REMARKS

Upon entry of the present Amendment A, claims 1-10 are pending in the application, of which claims 1 and 8 are independent. Claims 1, 6 and 8 are amended herein.

Application No. 10/804,479 Reply to Office Action Dated 21 April 2006 Amendment A ANNOTATED SHEET

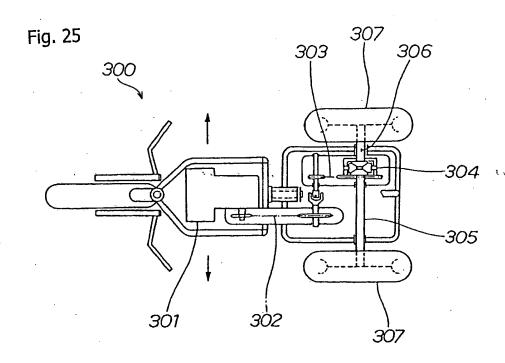
An attached sheet of drawings includes changes to Figure 7. This sheet, which includes

only Figure 7, replaces the original sheet which included only Figure 7. Figure 7 is amended

herein to include a front pivot axis FPA and a rear pivot axis RPA, previously omitted from this

drawing but described in the specification in paragraph 73.

Figure 7 is amended herein to include a front pivot axis FPA and a rear pivot axis RPA, previously omitted from this drawing but described in the specification in paragraph 73. These

axes coincide with the straight line 237 shown in Figs. 14 and 15. No new matter is added.
